Re: Agenda and Proposals for 4 February 1992 meeting of TURBOchannel Industry Group

Proposal for Change to the TURBOchannel Specification: Parity

Proposal for Change to the TURBOchannel Specification: I/O Read Byte Masking

Proposal for Change to the TURBOchannel Specification: DC Threshold Voltage

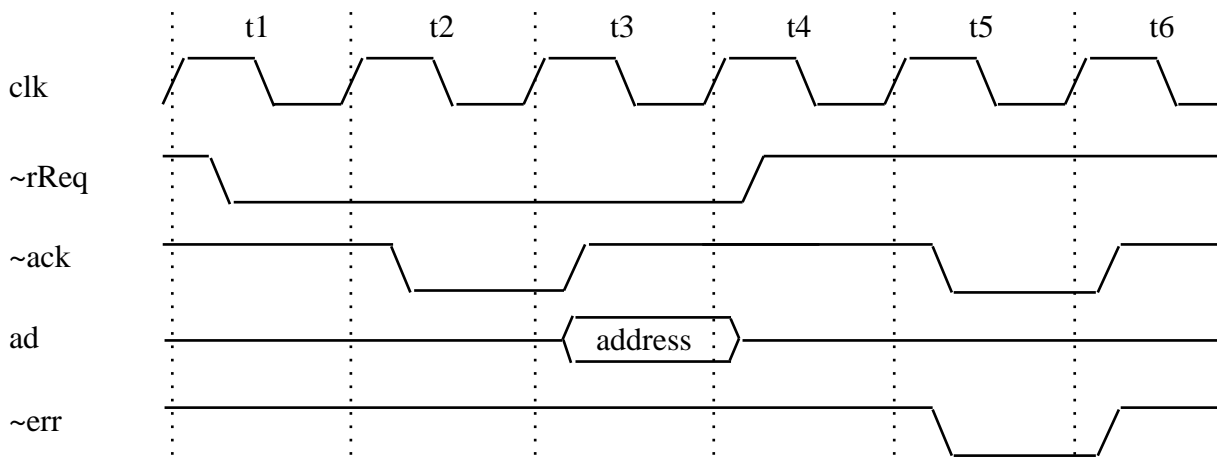
I/O Reads:

There is no mechanism for an option to return an explicit error acknowledgement if it detects a parity error in the slot address/mask. Hence, the option should generate a parity error interrupt and let the I/O read transaction timeout. The option TURBOchannel interface should not issue the read to its internal logic.

If the system detects a parity error in the I/O read data, it should generate a parity error interrupt and signal a bus error to the processor.

DMA read of 1 word with address parity error:

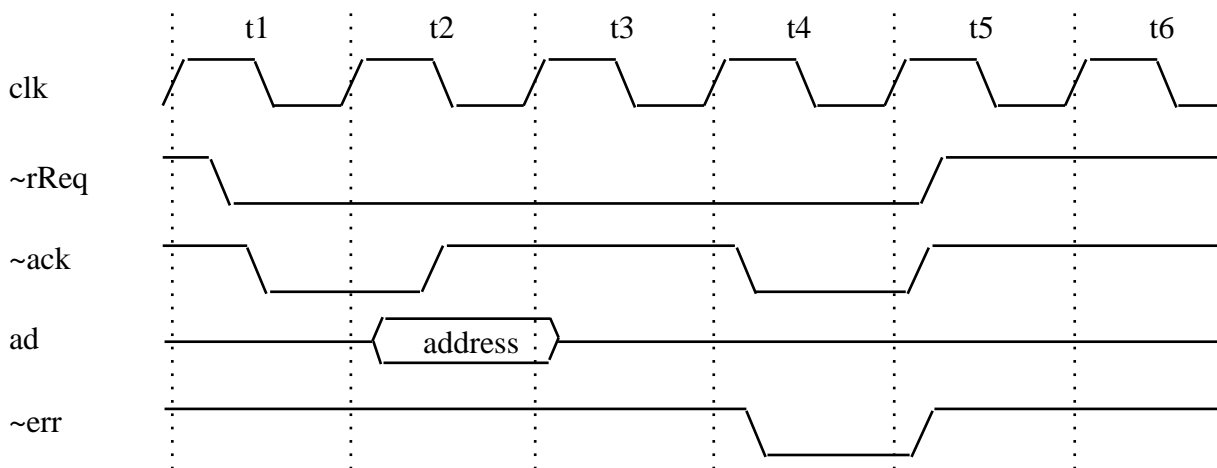
DMA Reads:

There is no mechanism for the system to explicitly signal a parity error of the DMA address. Hence, the system should assert \sim ack and \sim err for a period of one cycle following the address transfer. The system TURBOchannel interface should generate a parity error interrupt. It is recommended that the system TURBOchannel interface not issue the read to the memory system. The option must terminate its DMA transaction on the cycle immediately after the \sim err signal is asserted. The option TURBOchannel interface should generate a DMA error interrupt. The option TURBOchannel interface should indicate an error to its internal logic.

- t1: option requests a dma cycle
- t2: option is granted the bus
- t3: option drives address onto ad
- t4: system memory latency (may be many cycles)
- t5: system has detected ad parity error and asserts ~ack and ~err
- t6: idle cycle
